**ON-SITE SEWAGE DISPOSAL SYSTEM
HOWARD COUNTY HEALTH DEPARTMENT
BUREAU OF ENVIRONMENTAL HEALTH**

WALL CHECK DRAWING
DORMAN LOT
LIBER 10230 AT FOLIO 556
15210 FREDERICK ROAD
ELECTION DISTRICT NO. 4
HOWARD COUNTY, MARYLAND
SCALE: 1" = 50' JANUARY 2012

RE: Limitations on number of bedrooms, 15210 Frederick Road (PC525692)

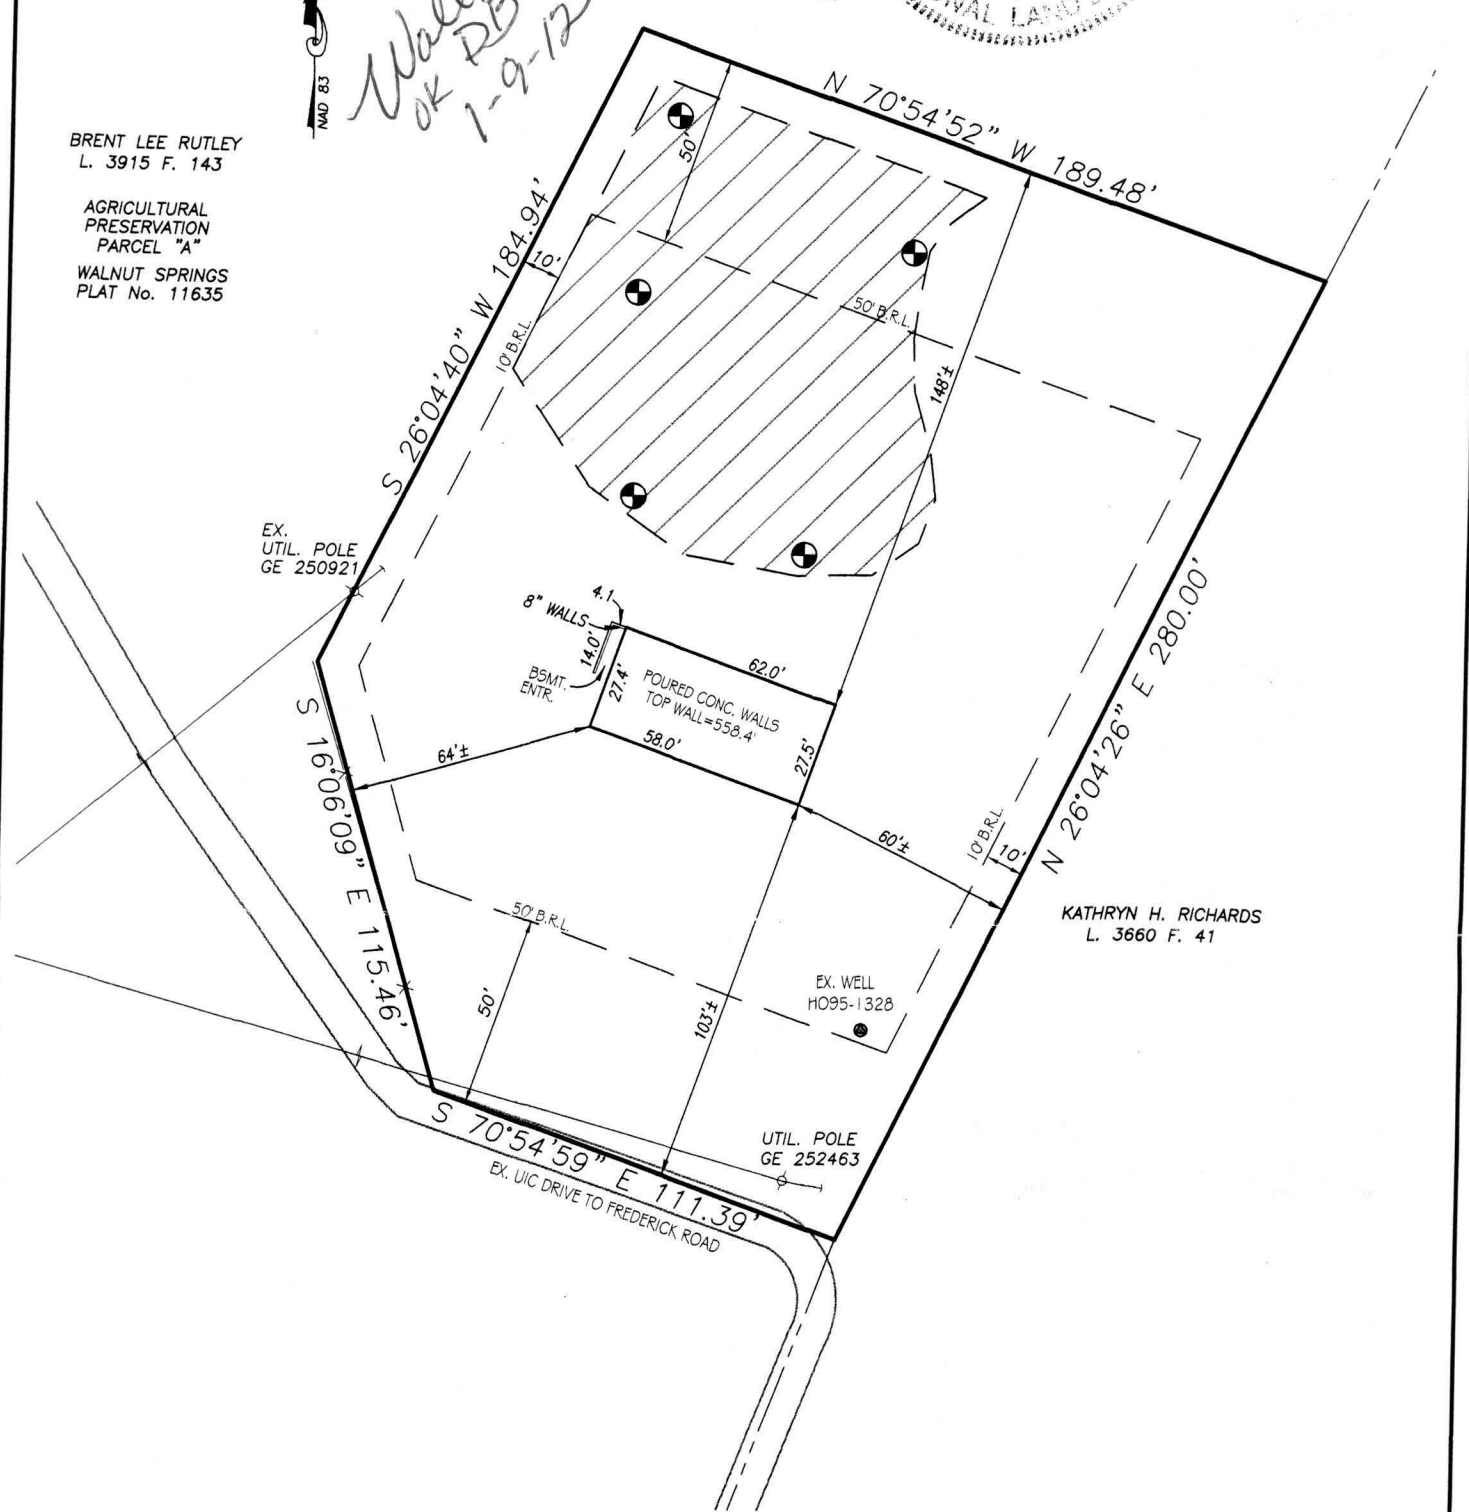
TRENCHES:	Trenches to be 2.0 feet wide. Inlet 4.0 feet below original grade. Bottom maximum depth 8.0 feet below original grade. Effective area begins at 5.0 feet below original grade with 4.0 feet of stone below distribution pipe.
LOCATION:	Set septic tank and pump tank near planned locations. Maintain gravity flow & 100' setback to well. Set distribution box at Northeast corner of septic reserve. Install 4 x 40 trenches on contour from north boundary of septic reserve. Maintain at least 8 feet of separation wall to wall.
NOTES:	Do not order the septic tank until after layout inspection and Sanitarian approval. Stake easement corners. Call for layout inspection. Mark utilities. Gravel tickets must be available for Environmental Sanitarians. Stone must be approved by the Howard County Health Department. A written variance request is required for tanks deeper than 3 feet. A traffic bearing lid is required for tanks deeper than 4 feet. North property line must be marked. Check former drywell location for concrete cap (should not be there).

*Wall Check
OK DB
1-9-12*

SEPTIC TANK CAPACITY (GALLONS): 1500 ~~2000~~ OUTLET BAFFLE FILTER REQUIRED

LINEAR FEET OF TRENCH REQUIRED: 165'
